THORNTON O'CONNOR
TOWN PLANNING

RE: RESPONSE TO REQUEST FOR FURTHER INFORMATION

South Dublin County Council Register Reference SD22A/0290

Figure 2.4: SuDS Tree Pit Details

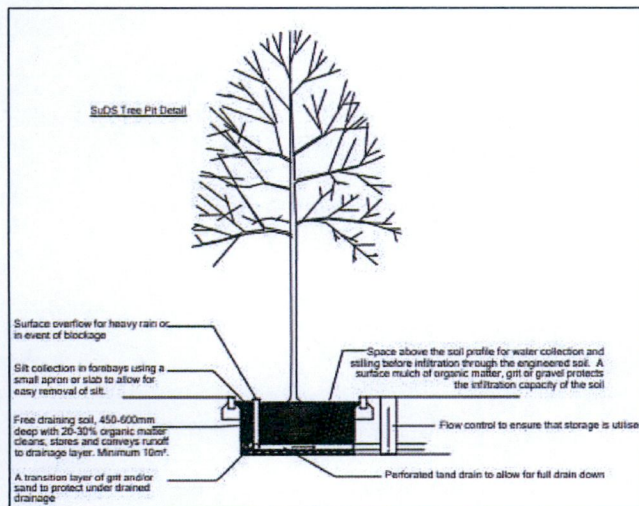
The applicant is requested to submit a Green Infrastructure Plan and Green Infrastructure proposals to help mitigate and compensate for the impact of the proposed development on existing vegetation within the subject site. These proposals shall include additional landscape details, SUDS measures (such as permeable paving, green roofs, filtration planting, above ground attenuation ponds etc) and planting for carbon sequestration and pollination. Response shall include drawings.'

Please see the Green Infrastructure Report enclosed entitled *'Green Infrastructure Report & Landscape Rationale'* prepared by Enviroguide Consulting Engineers. This report contains details of green infrastructure and landscape architectural proposals, public realm and boundary treatments, internal green infrastructure and SuDS and biodiversity. It should be read in conjunction with the *'Landscape Management and Maintenance Plan'* also prepared by Enviroguide Consulting Engineers. Drawings No. P-02 and P-03 also compliment these reports with planting details.

Figure 2.6: Location of Bird and Bat Boxes

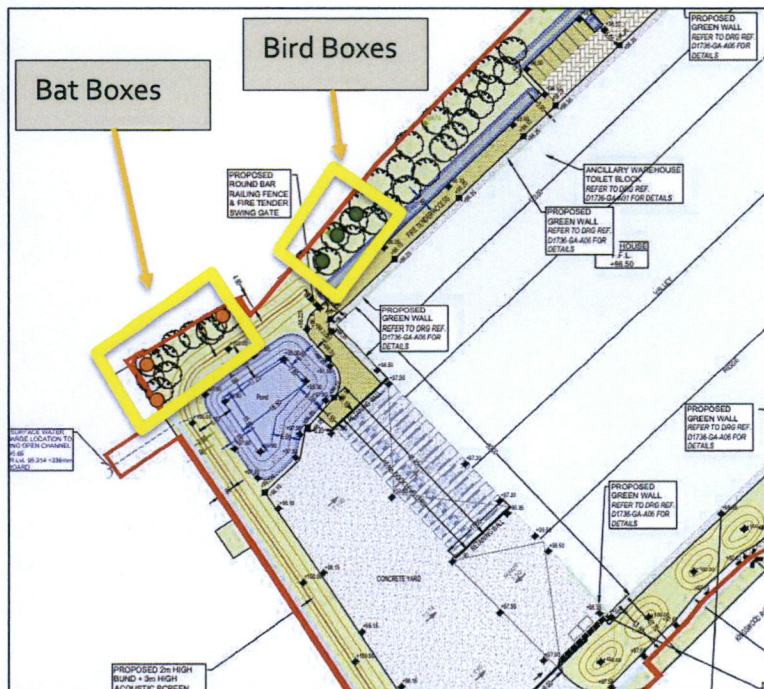
The applicant is requested to provide a scheme for the erection of bird boxes and bat boxes/tubes throughout the development.'

Please see enclosed 'Landscape Masterplan' prepared by Enviroguide Consulting Engineers which indicates the locations of the bird and bat boxes on the site. Figure 2.6 below shows the proposed locations of the bird/bat boxes now proposed on the site.

As shown on Figure 2.6 above, there are 3 No. bird boxes and 3 No. bat boxes included within the scheme. The bird boxes are located along the western boundary of the site and the bat boxes are located in the south western corner of the site.

Figure 2.8: Amended RFI Stage North-East Elevation

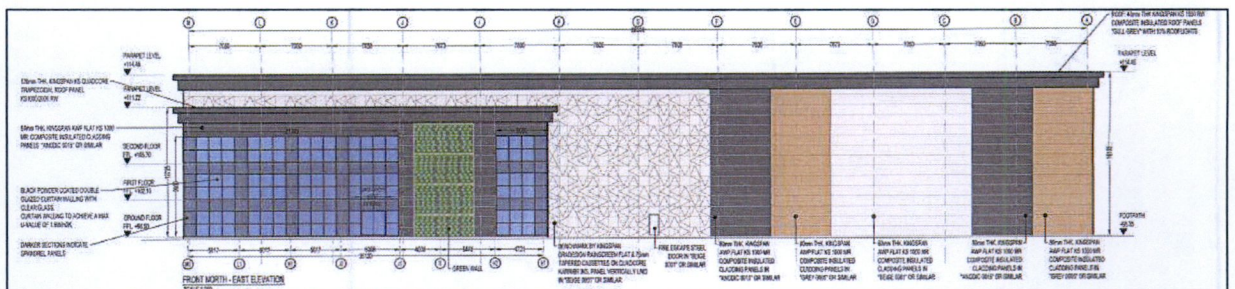
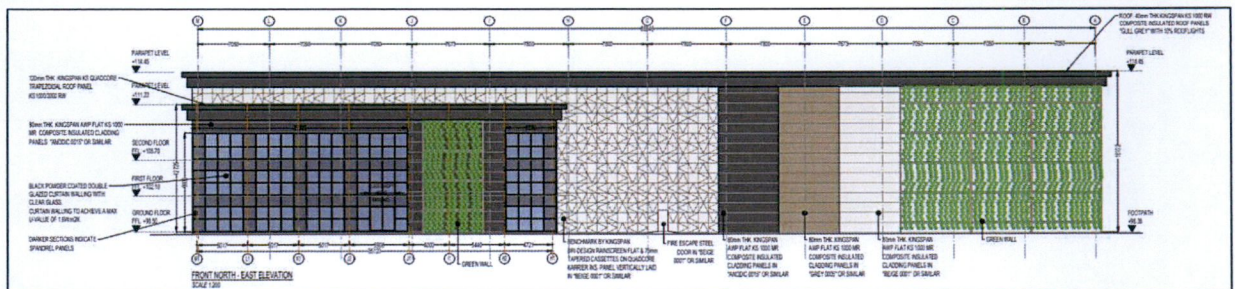
'The applicant is requested to amend the north-east elevation to provide additional warehouse wall screening, to soften the impact of the warehouse at this location.'

Please see the enclosed elevational drawings prepared by Kavanagh Burke Consulting Engineers. Drawing No. D1736-GA_Ao6 shows the proposed elevational changes to the North-East Elevation which includes additional wall screening. There has been an increase in green walls to all four sides of the building. The original elevation as provided in the as-logged scheme can be seen in contrast to the amended RFI elevation below:

Figure 2.9: Site Plan Prepared by Kavanagh Burke Displaying the Land up to the Office Development to the North.

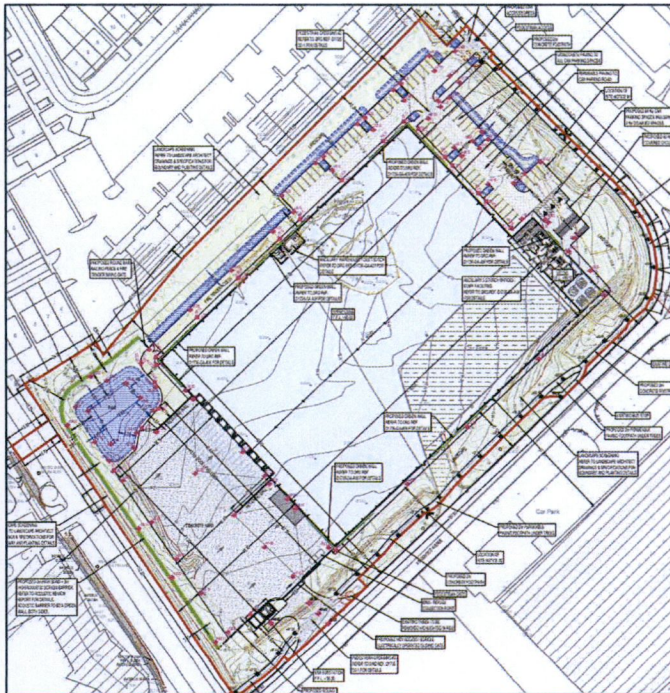
'The applicant is requested to clarify the relationship between landscaping proposals and the existing office development to the north. In addressing this relationship, the applicant shall clarify the exact site boundary up to the office development, clarifying who currently manages the grassed land between the indicated site boundary and the assumed boundary of the office development.'

Kavanagh Burke prepared a Site Plan (Dwg. No. D1736 – D2) which shows the office development to the north of the subject site. The red line on drawing No. D1736 – D2 denotes the land which is under the ownership of the applicant and is proposed to be landscaped as part of the subject scheme.

'The exact boundary lies along the footpath edge of the existing office development to the north. The grass land is maintained by City West management.'
